SERVICE LETTER SL47 65-17190

1. Release Date: 12/26/2019
2. Service Letter No.: SL47 65-17190
3. Subject: LSP Cable Installation
4. Part/Assembly No.: 65-17190
5. Float Model Affected: 6650 and 6750
6. Compliance: Mandatory Recommended Optional
7. Approval: All information provided is in accordance with approved data.
8. Corrective Action: Non-required.
9. Time Required: Approximately 1 hour.
10. Payments: Credit to Customer Under Warranty Customer Pays

DETAIL D-1
WHEEL WELL ROUTING
SCALE 1 : 1

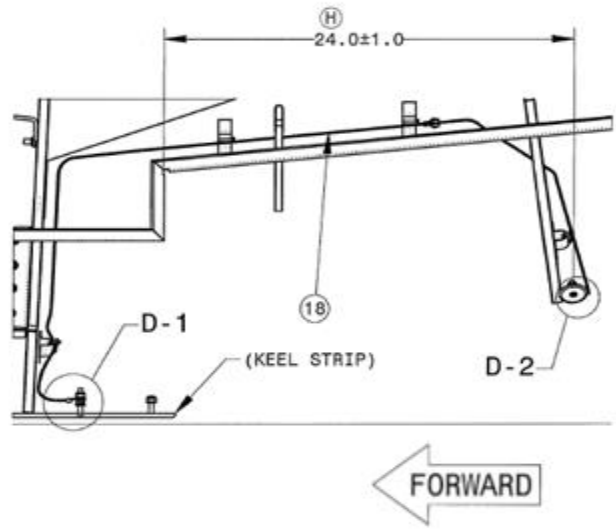
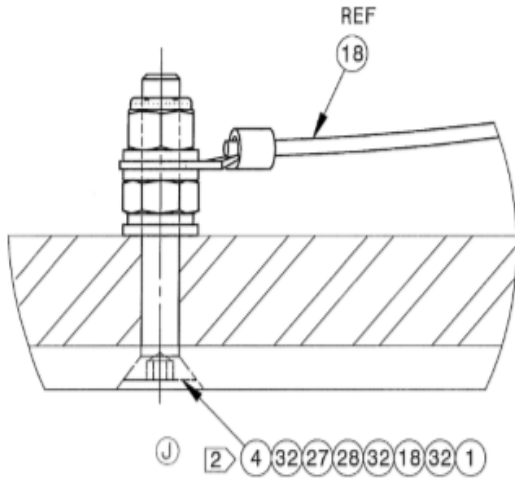
The current lightning strike protection (LSP) configuration is connected thorough use of keel installation fastener at Float STA. -4.63 which falls inside the Main landing Fear (MLG) box. That was in turn routed aft to the next fastener for the aft keel strip.

The purpose of this service letter is to explain the move of the LSP connection between fore and aft keel strips at the MLG so that it does not penetrate the gear box, and is therefore, higher in the waterline. This will eliminate sealing issues sometimes encountered where the wire passes through the box below the waterline. The LSP wire connection at the nose gear moved outboard for better access and increased distance from hydraulics.

The wire connection and hardware were moved to the next forward keel strip installation hole, allowing the LSP wire to only penetrate the bulkhead, which is inside the sealed compartment, and routed to the aft termination (unchanged).

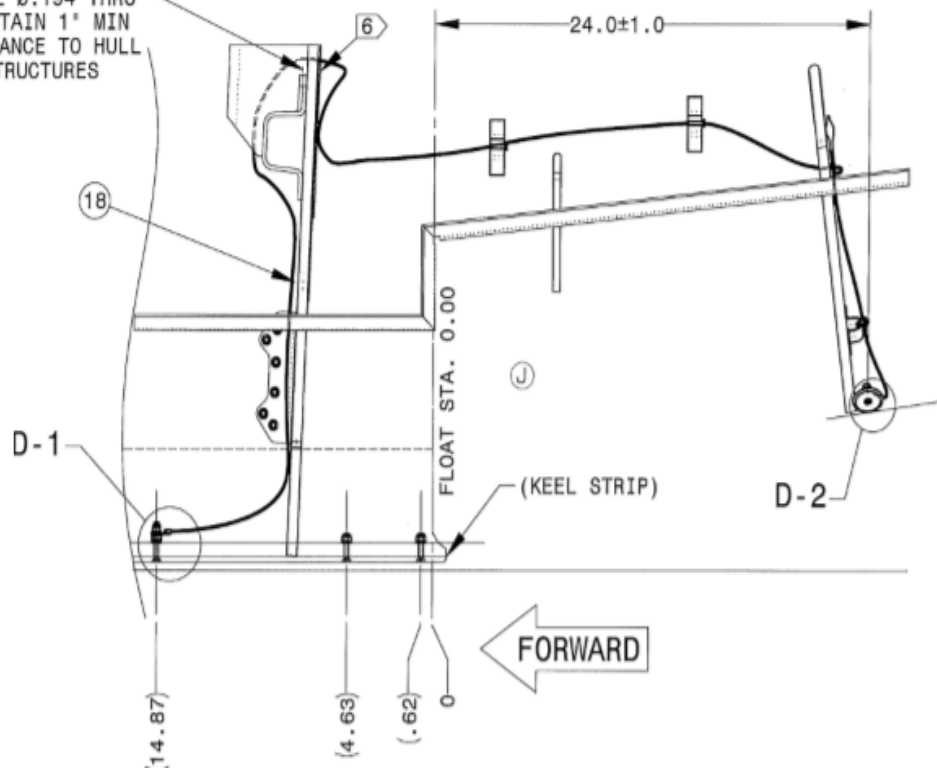
DRILL Ø.194 THRU
MAINTAIN 1" MIN
CLEARANCE TO HULL
STRUCTURES

Note 9 (NEW)

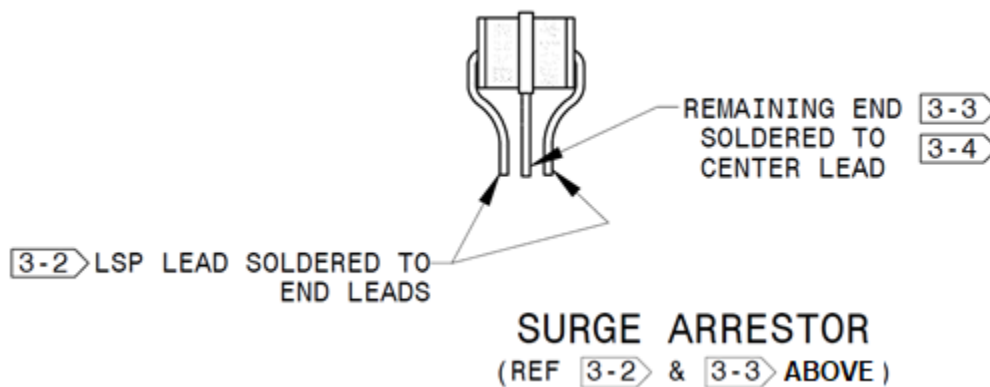
Note 5 changed to:

5. USE TECHFLEX™ “FLEXO FR” EXPANDABLE SLEEVING TO PREVENT CHAFING OF CABLE AGAINST SURFACES WHERE NECESSARY. SECURE ENDS OF SLEEVING WITH MS3367-4-9 TIE WRAPS OR HEAT SHRINK SLEEVING, SUCH AS MS23053/4-302 OR M23053/5-305. M23053 SLEEVING SHALL BE FLEXIBLE, CLASS 3, COLORATION OPTIONAL, SIZE AS REQUIRED.

9. INSULATION SLEEVING DIAMETER MAY BE ADJUSTED AS NECESSARY TO ASSURE PROPER FIT. USE M23053/5, CLASS 3 WHERE SEALING IS REQUIRED. M23053/5 OR SIMILAR IS SUITABLE WHERE USED TO SECURE ITEMS OR TO PROVIDE CAFÉ PROTECTION.
